LICENSEE: Nuclear Management Company, LLC
FACILITY: Point Beach Nuclear Plant, Units 1 and 2
SUBJECT: SUMMARY OF TELEPHONE CONFERENCE HELD ON JANUARY 10, 2005,
BETWEEN THE U.S. NUCLEAR REGULATORY COMMISSION AND
NUCLEAR MANAGEMENT COMPANY, LLC, CONCERNING REQUESTS FOR
ADDITIONAL INFORMATION PERTAINING TO THE POINT BEACH NUCLEAR
PLANT, UNITS 1 AND 2, LICENSE RENEWAL APPLICATION

DRAFT REQUESTS FOR ADDITIONAL INFORMATION (RAI)
POINT BEACH NUCLEAR PLANT, UNITS 1 AND 2
LICENSE RENEWAL APPLICATION

RESPONSE TO REQUEST FOR ADDITIONAL INFORMATION POINT BEACH NUCLEAR PLANT, UNITS 1 & 2 LICENSE RENEWAL APPLICATION

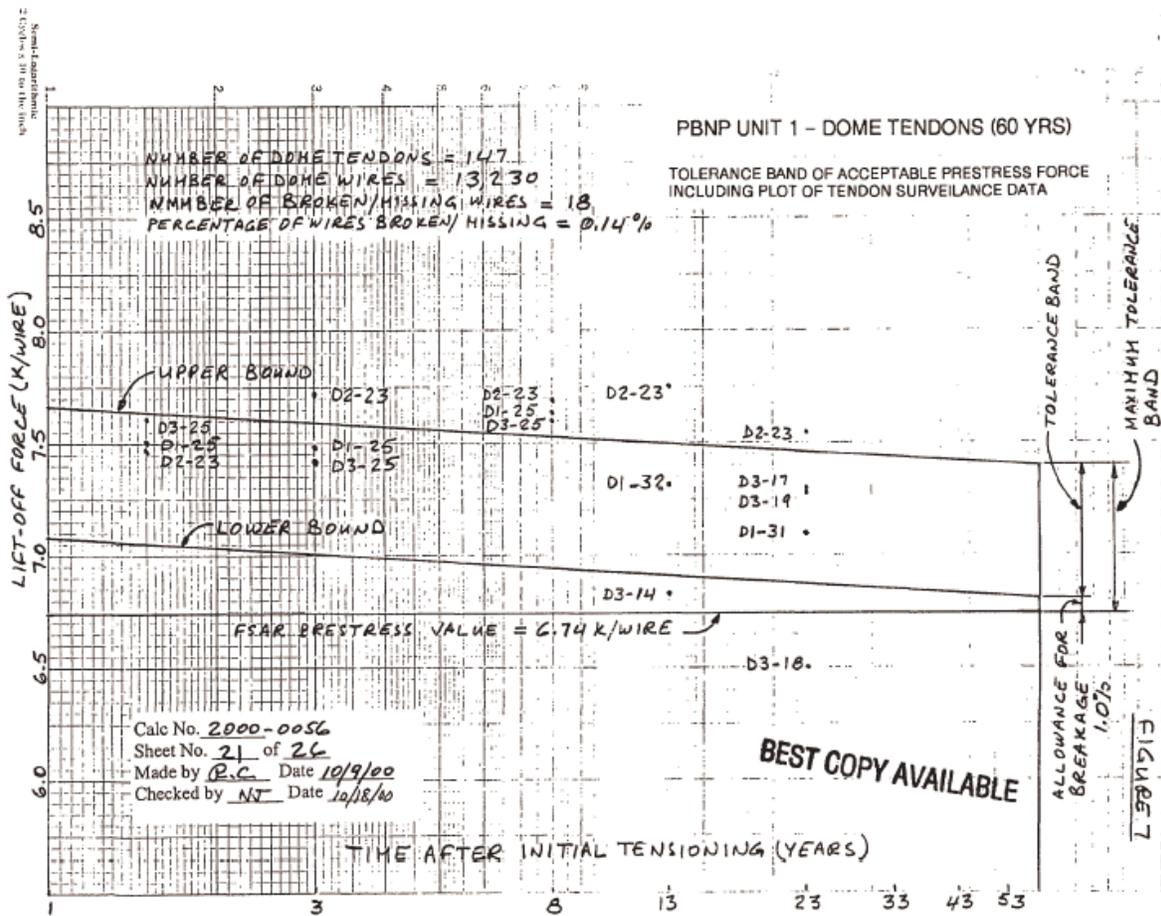
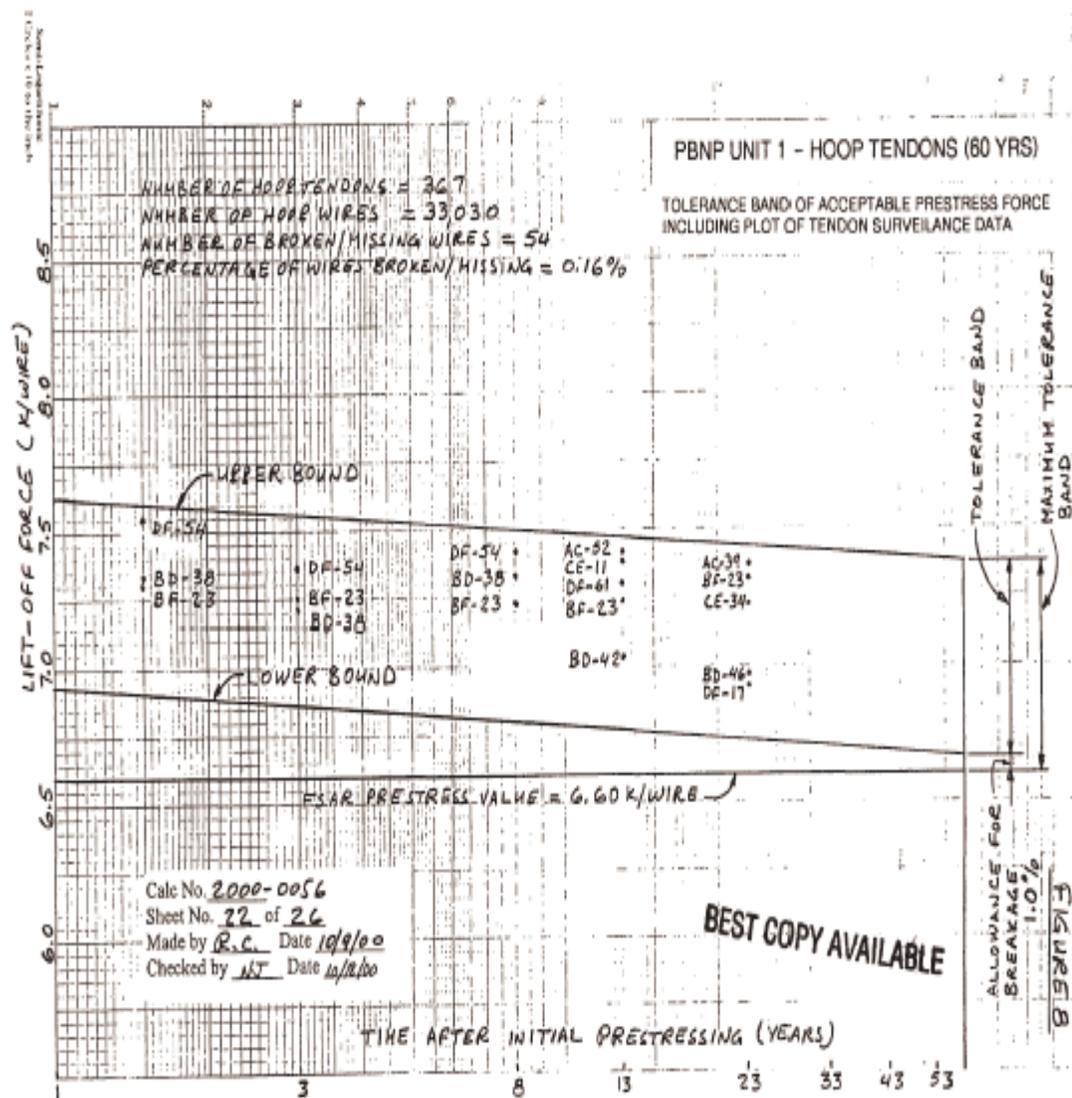
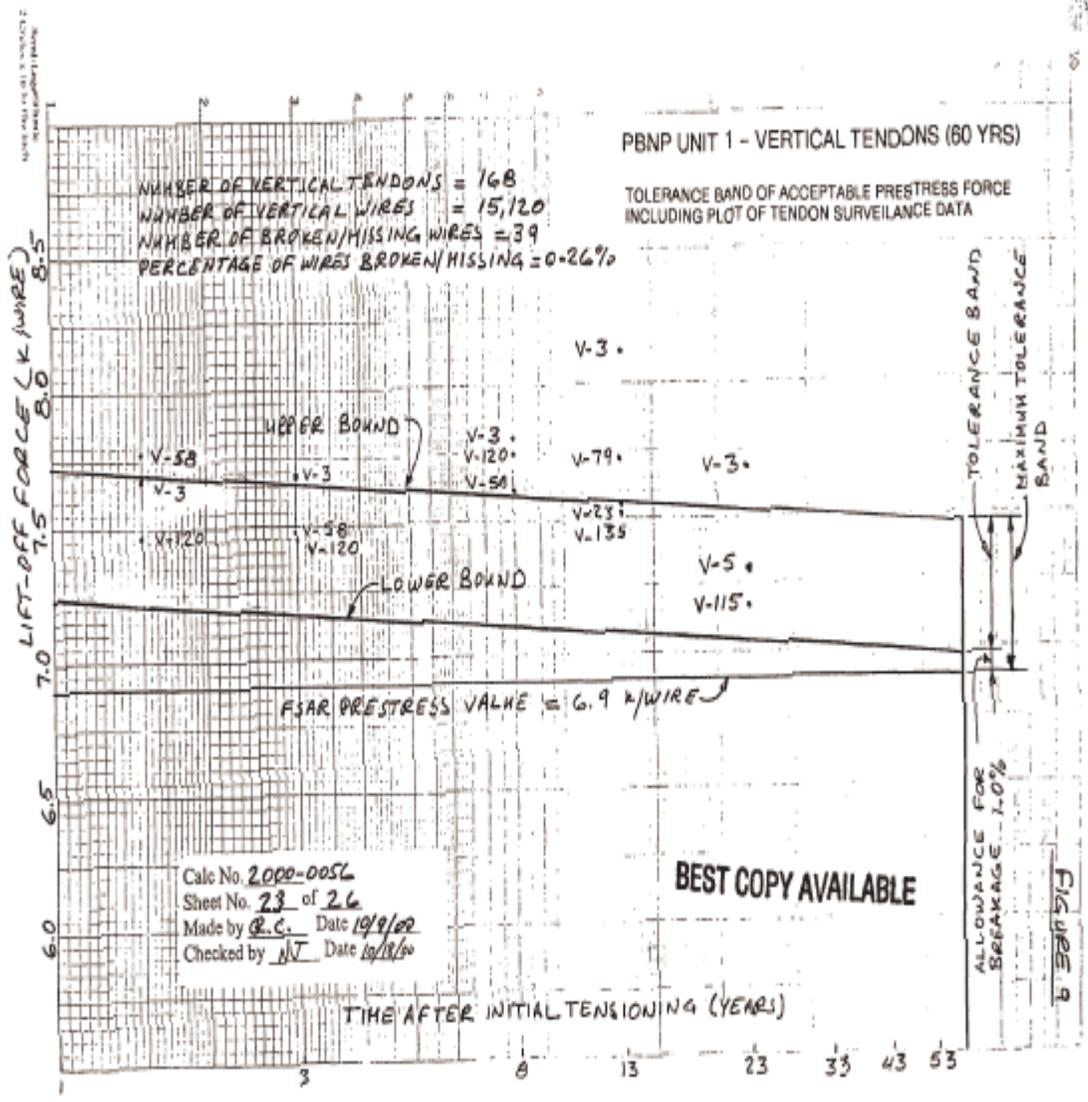
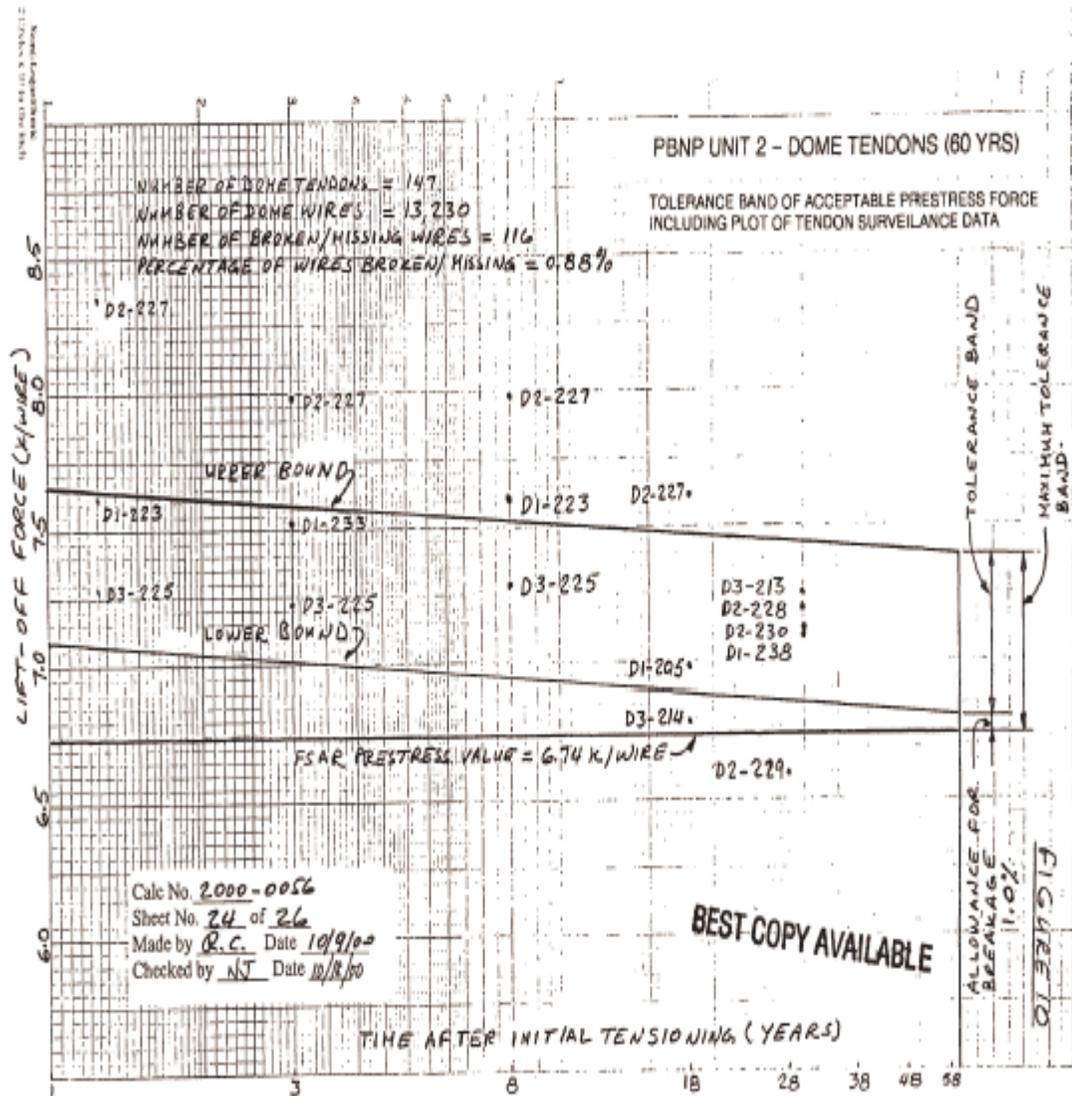
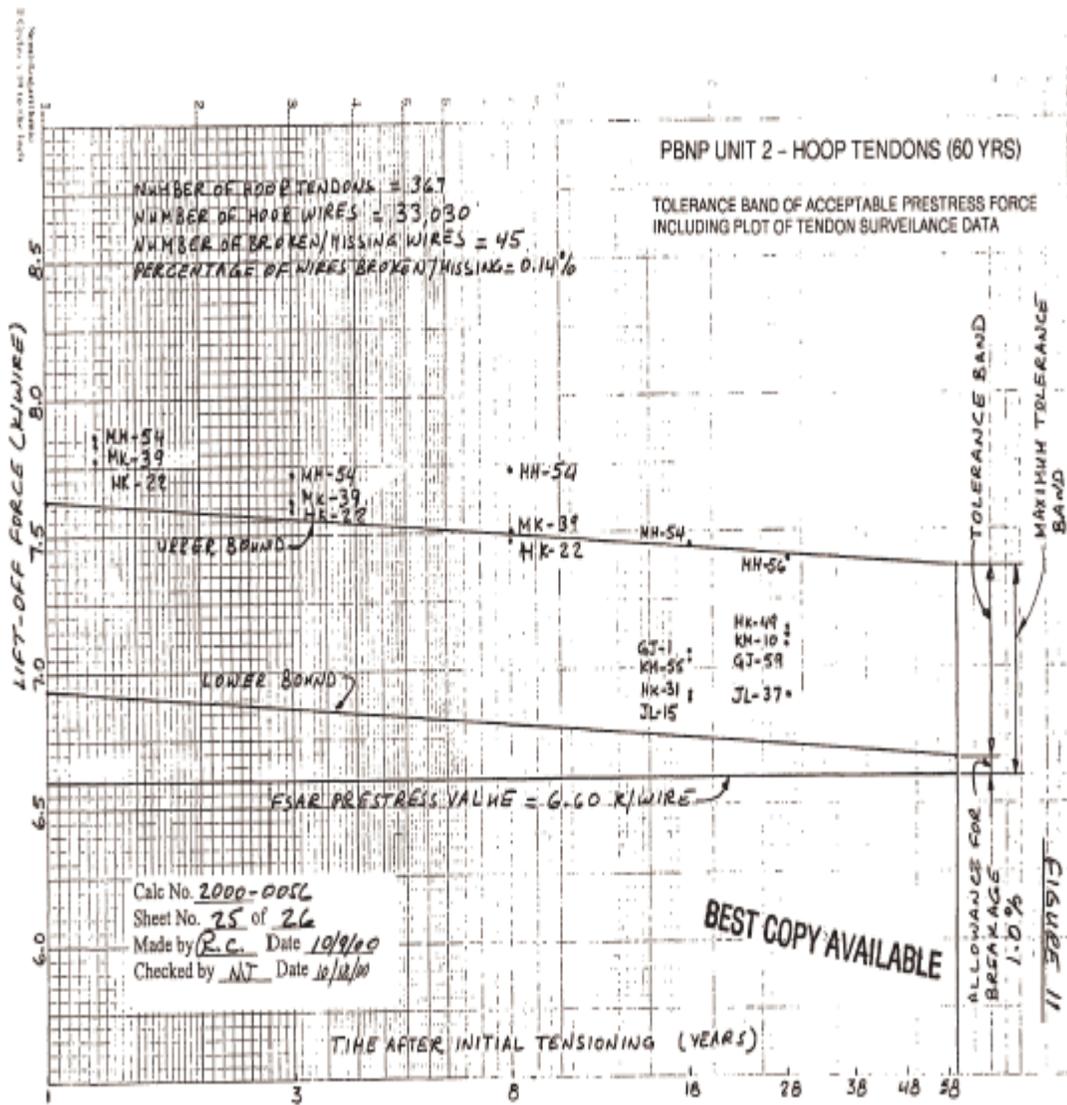
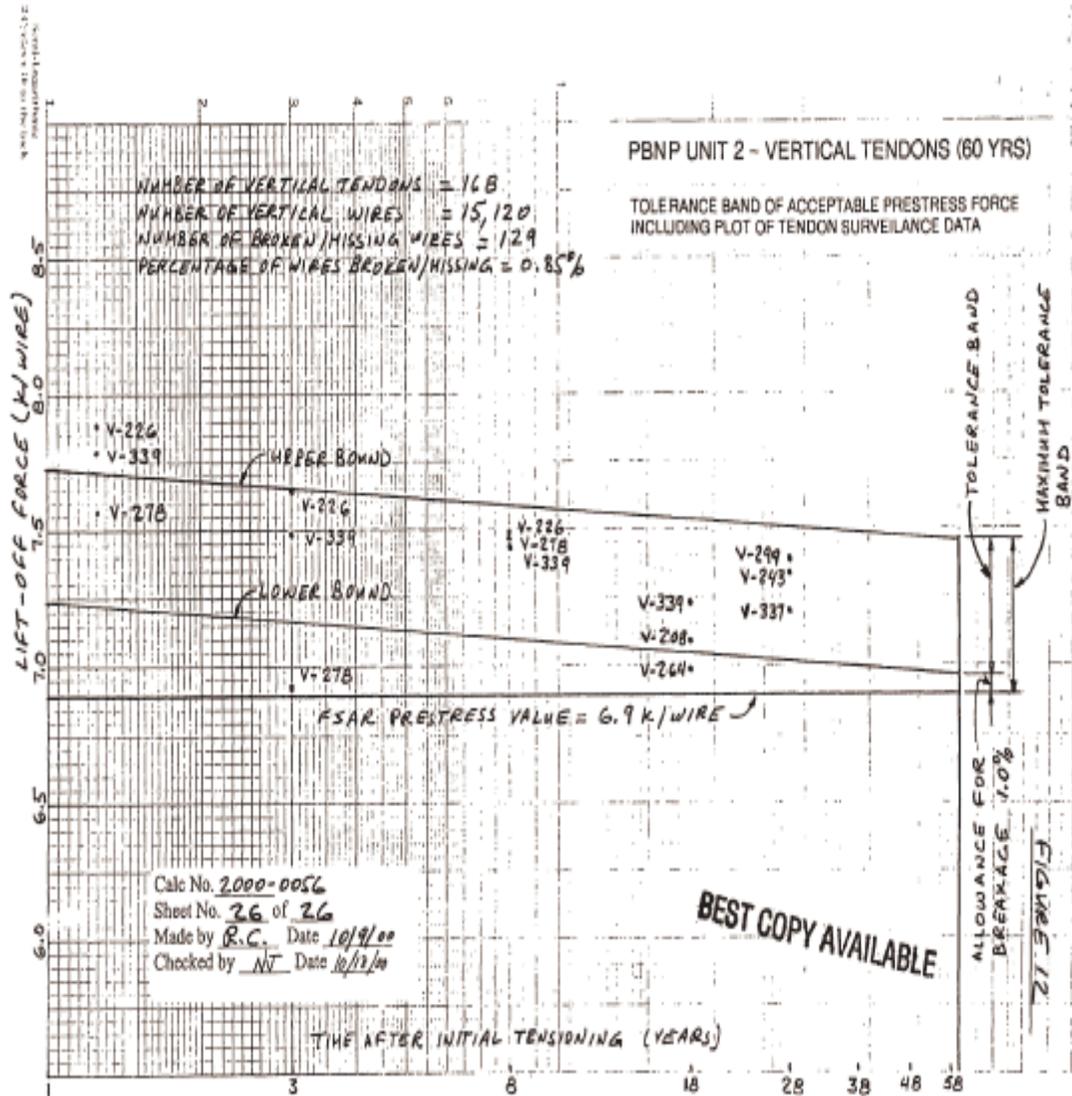
The use of 10 CFR 54.21(c)(1)(ii) and (iii) is appropriate for concrete containment tendon prestress TLAA. However, the staff need to assess the plant specific operating experience regarding the residual prestressing forces in the containments and the methods used to arrive at the projected prestress forces. Based on the analysis performed as per 10 CFR 54.21(c)(1)(ii), the applicant is requested to provide the following information:

- a. The estimated upper and lower bound lines, and the minimum required prestressing forces for each group of tendons for each containment.
- b. Trend lines of the projected prestressing forces for each group of tendons based on the regression analysis of the measured prestressing forces (see NRC Information Notice 99-10 for more information). Also, show the actual measured prestressing forces that were used to obtain the trend lines.
- c. Plots showing comparisons of prestressing forces projected to 40 years and 60 years with the minimum required prestress (or MRV) for each group of tendons for each containment.

A set of tendon prestressing plots have been developed in accordance with RG 1.35.1, reference Calculation 2000-0056, Tendon Prestress Acceptance Limits, Rev. 0. The plots for 60 years (6 total) include the upper and lower bound lines and the minimum required prestressing force for each group of tendons for each of the containments per RG 1.35.1.
